TX650A, XS650B/650C HEADLIGHT MOUNT DESIGN CHANGE

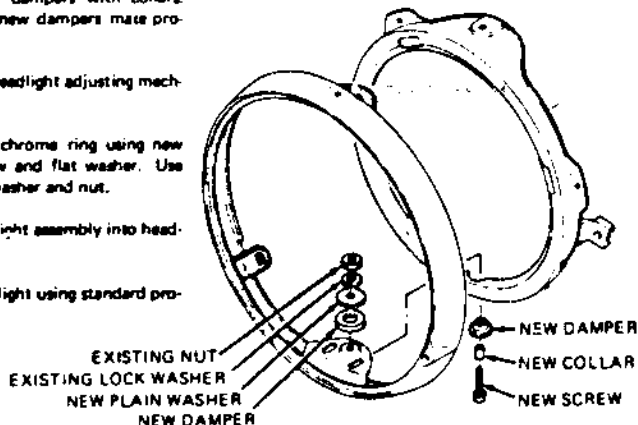
A redesigned headlight mounting ring is now available for the TX650A, XS650B and XS650C. The new mounting ring has increased damping characteristics to help reduce vibration and increase headlight service life.

1. Remove headlight and chrome ring from headlight body.
2. Remove headlight adjustment screw, spacer, washer, spring and nut.
NOTE: XS650C and some XS650B models do not have spacer and washer.
3. Remove chrome ring and two rubber dampers.
4. Remove headlight mounting ring.

1. Install new headlight mounting ring. Discard old mounting ring.
2. Install new dampers with collars. Make sure new dampers mate properly.
3. Install old headlight adjusting mechanism.
4. Install old chrome ring using new longer screw and flat washer. Use old spring washer and nut.
5. Install headlight assembly into headlight body.
6. Adjust headlight using standard procedure.

REPLACEMENT OF HEADLIGHT STAY

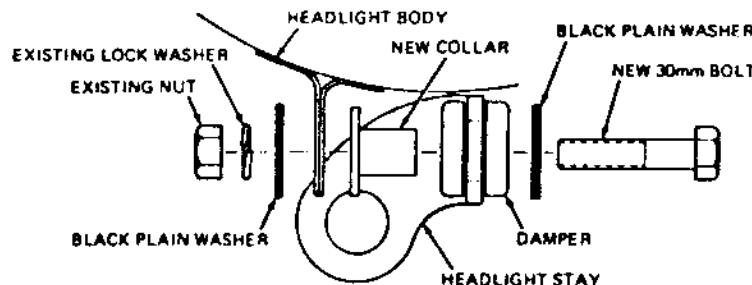
1. Remove old headlight stay from headlight body.
2. Install new stay to under bracket using old damper and collar. Use new 25mm bolt.
3. Install new damper on ear of new stay which has flat cut on its radius.
4. Attach stay to headlight body using new 30mm bolt, two black plain washers, new collar and old spring washer.
